Project Name: Proposed Riverside South Elementary School, 836 Solarium Avenue, Ottawa, Ontario
EXP Project Number: OTT-22012013-A0
Subject: Geotechnical Response to First Round of Comments from City of Ottawa
 City of Ottawa File No. D07-12-22-0145

FIG. 1

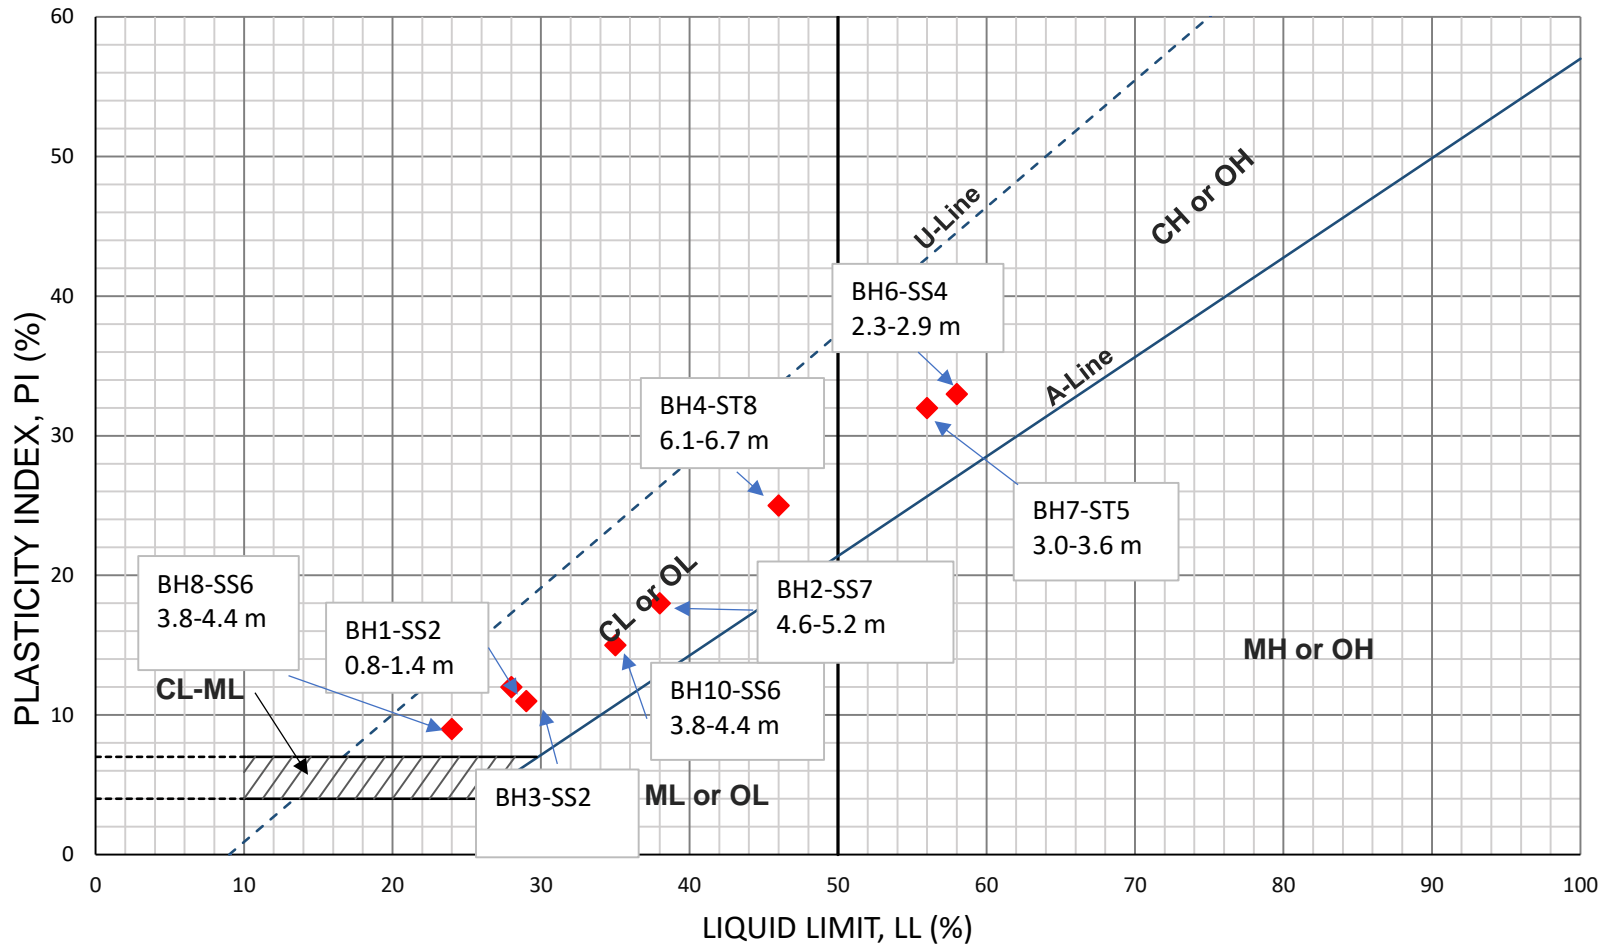
City of Ottawa Comment 1.26: Please append the results of the Atterberg limit laboratory testing.

EXP Response to Comment 1.26: *The Atterberg limit test results (liquid limit and plastic limit) and the determination of the plasticity index values of the clayey silt and clay soils are provided in Table IV (page: 9) of the final geotechnical report dated September 21, 2022 and shown below. The soil plasticity chart is shown in the attached Figure 1.*
